CITY OF ALBUQUERQUE

RE: **Cherokee Subdivision**
1304 Cherokee NW
Grading Plan Engineer's Stamp Date: 1/12/18
Drainage File: G14D089

RE: **Cherokee Subdivision**
1304 Cherokee NW
Grading Plan Engineer's Stamp Date: 1/9/18
Drainage File: G14D089

ENGINEER'S SEAL DAVID SOULE P.E. #14522	CHEROKKE ROAD	DRAWN BY WCVJ
	GRADING AND DRAINAGE PLAN	DATE 1-07-17
1/12/18	 Rio Grande Engineering 1606 CENTRAL AVENUE SE SUITE 201 ALBUQUERQUE, NM 87106 (505) 872-0999	21845-LAYOUT-1-07-18
		SHEET #
		JOB # 21845

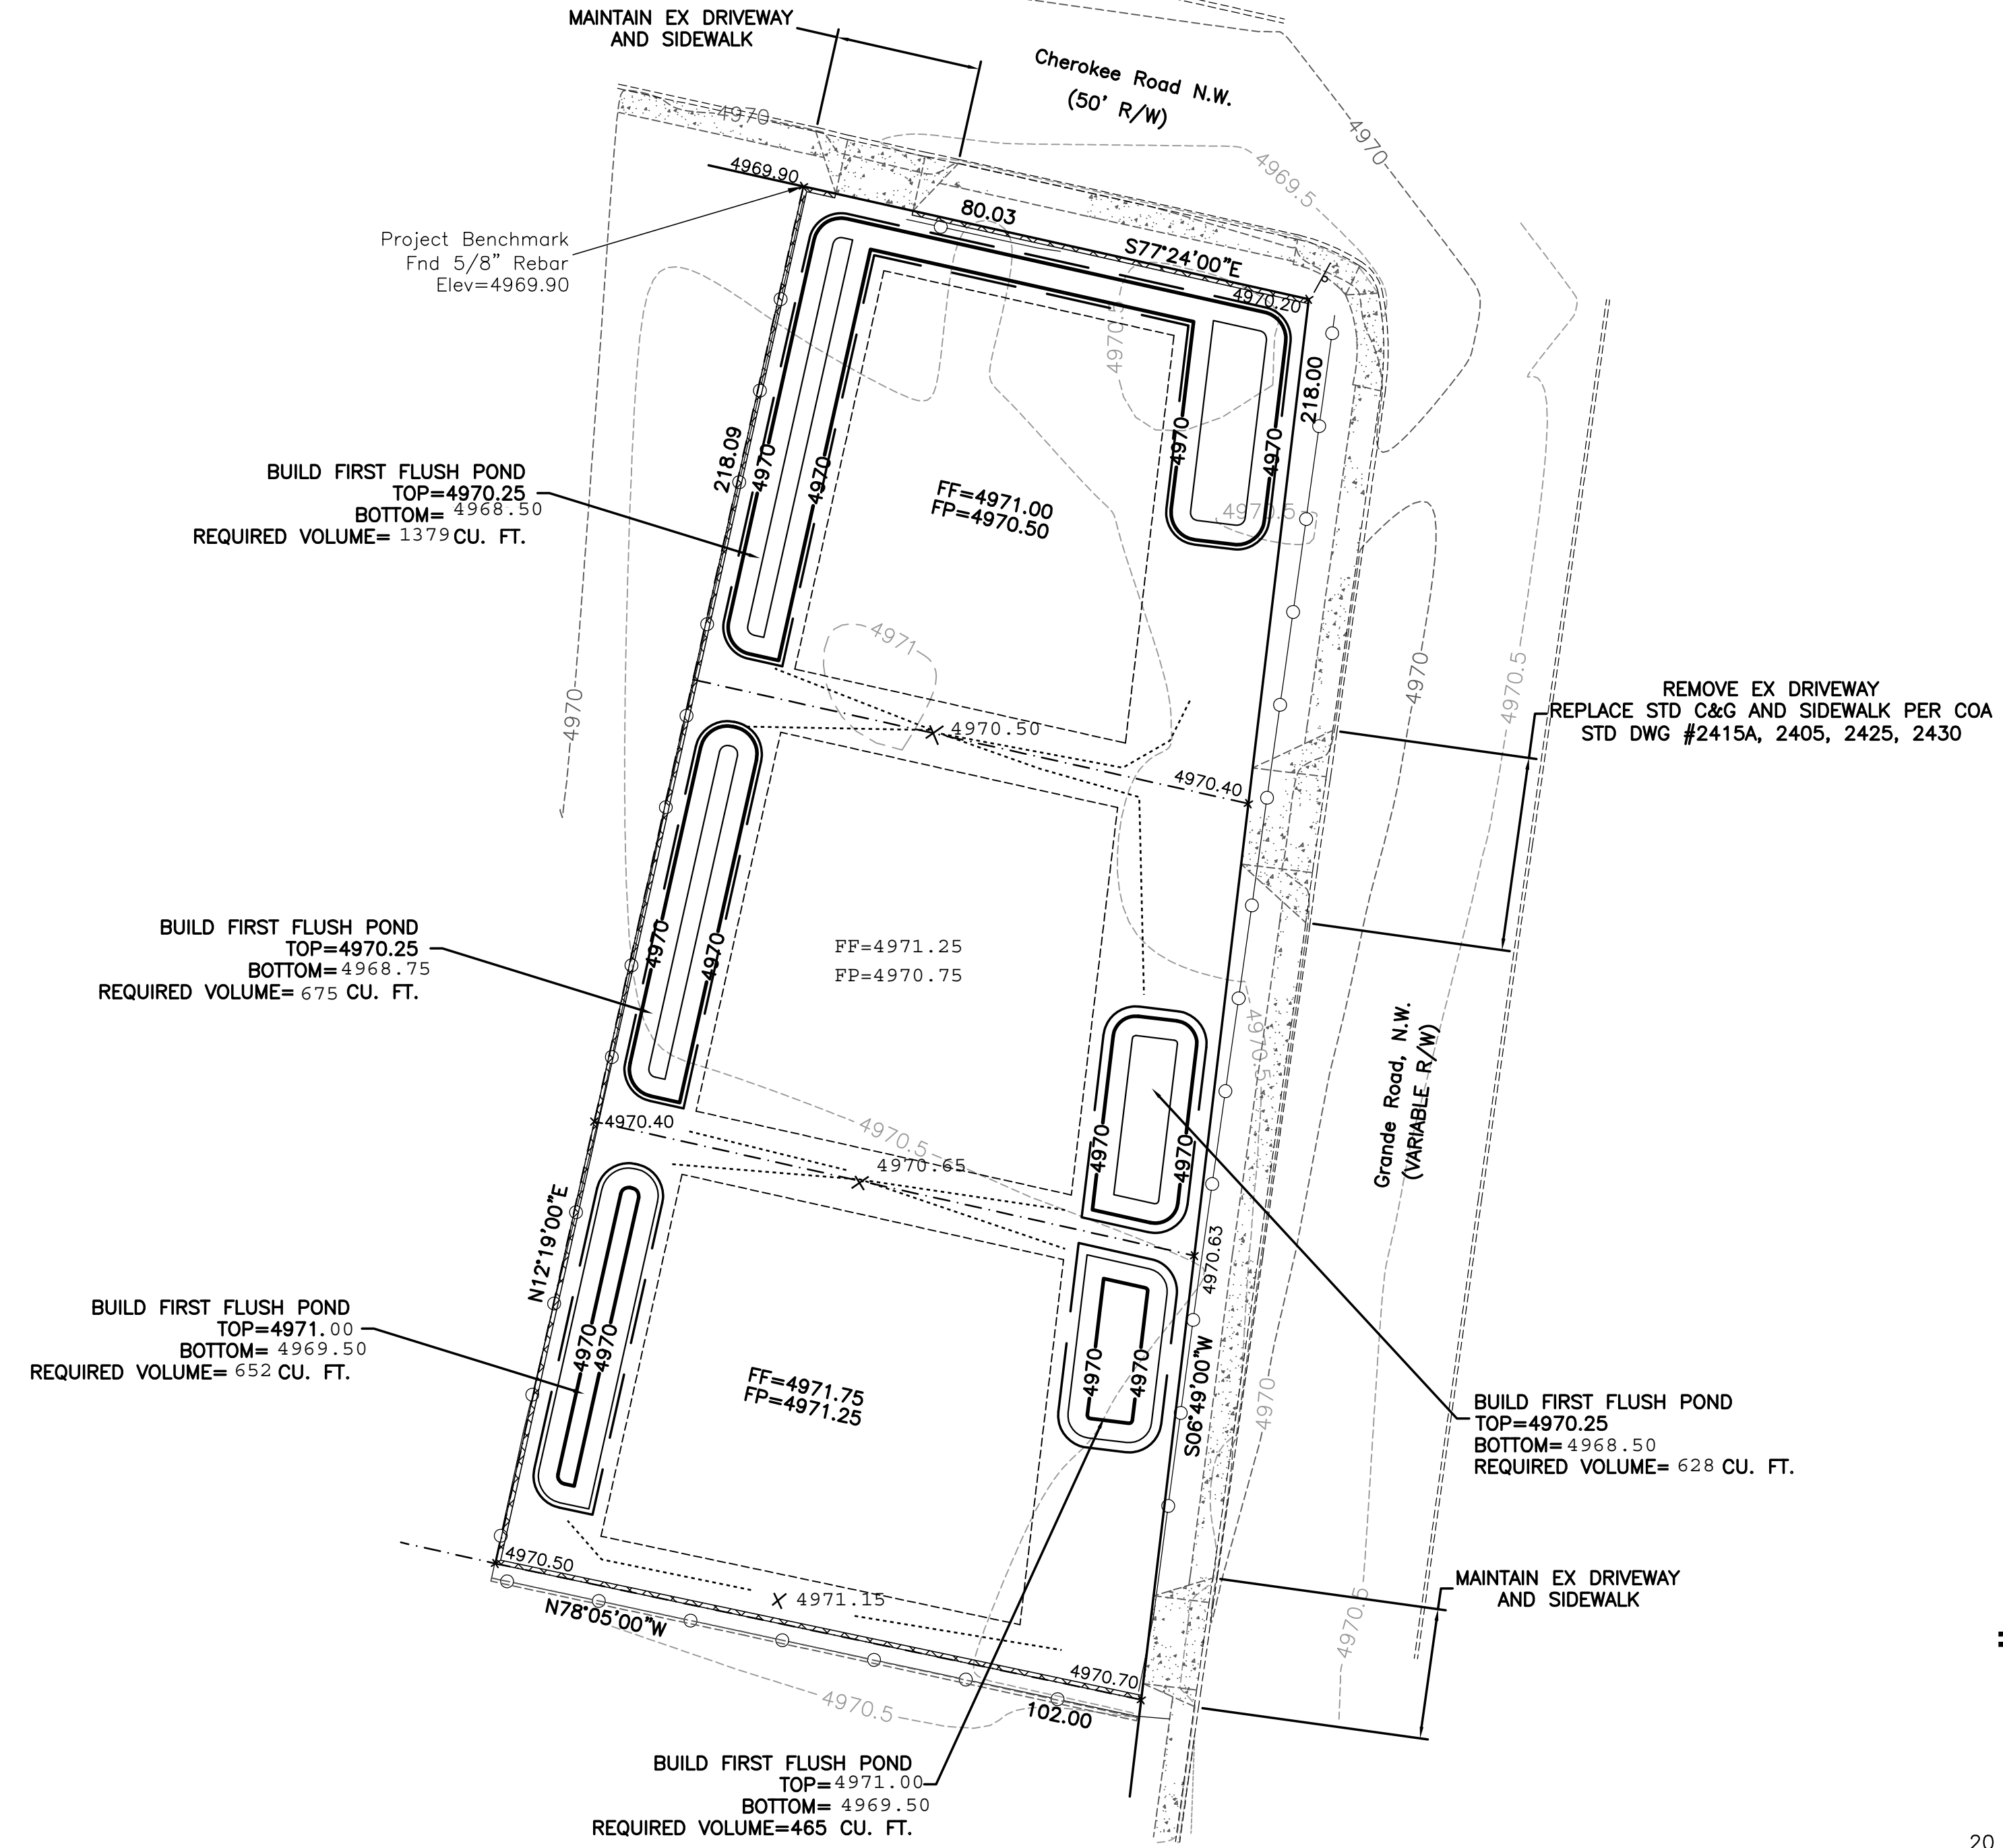
1. Provide onsite ponding volume on each lot for the 100-year, 10day volume; infiltration rates cannot be accepted in lieu of this volume requirement. **UPDATED CALCULATIONS**
2. Please add swales along the side yards to direct runoff into the ponds.

ADDED
